**APPENDIX A**  
**NOP AND SCOPING COMMENTS**

### **NOTICE OF PREPARATION**

#### **SHERWIN-WILLIAMS DEVELOPMENT PROJECT ENVIRONMENTAL IMPACT REPORT (EIR)**

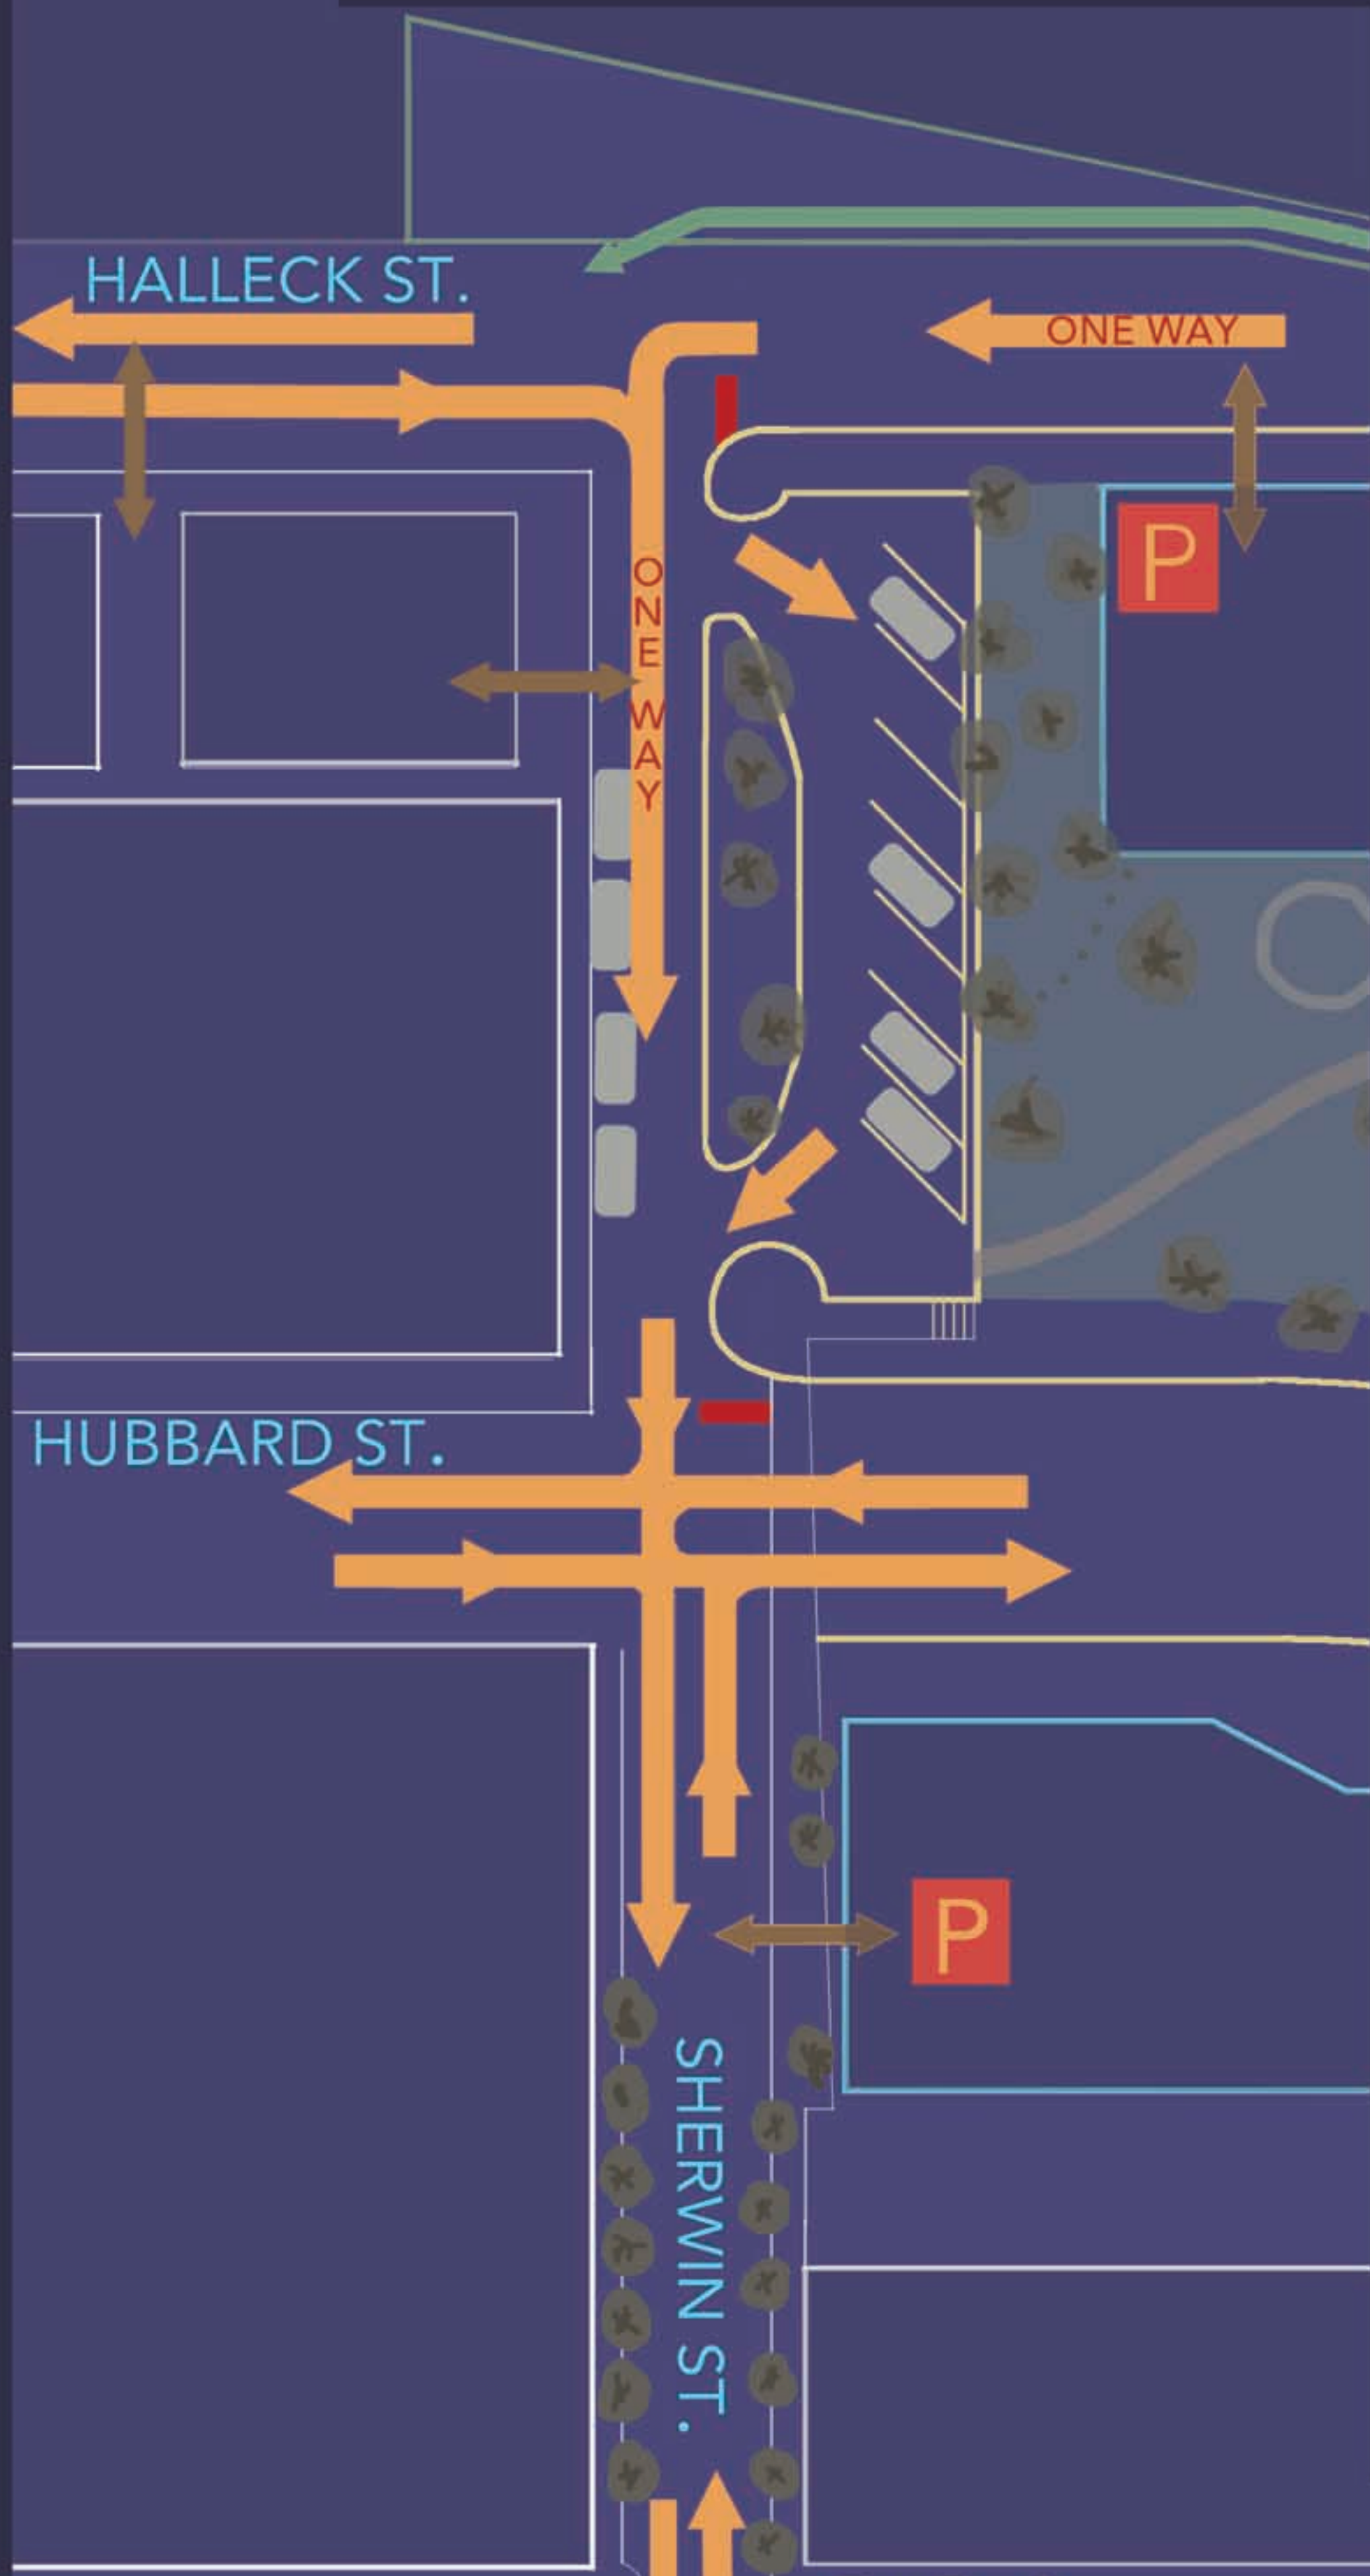
How will increase of completed project traffic noise levels effect live/work residents with windows on Horton St. between the two intersections, 45th and Horton and Sherwin and Horton ( consider narrow street width and the corridor created by Building 131)?

How will vehicle emissions increase at Hubbard street extension, where acceleration will be needed to travel up the incline onto raised PUD grade level?

How will noise increase from vehicles accelerating from the Hubbard St./Sherwin stop sign up the incline onto raised PUD grade level?  
(consider acoustic conditions of Grifols building on south side of Sherwin St., between Hubbard and Horton. Consider easterly prevailing wind conditions.)

City of Emeryville Green Streets Guidelines suggest 15' sidewalk widths. Horton Street is a Green Street. The Horton Street sidewalk between Sherwin Street and 45th. Street is 12' wide. The roadway, curb to curb is 35'9". Study is required to assess the impacts of sidewalk widening to allow the PUD to comply with Green Street Guidelines.
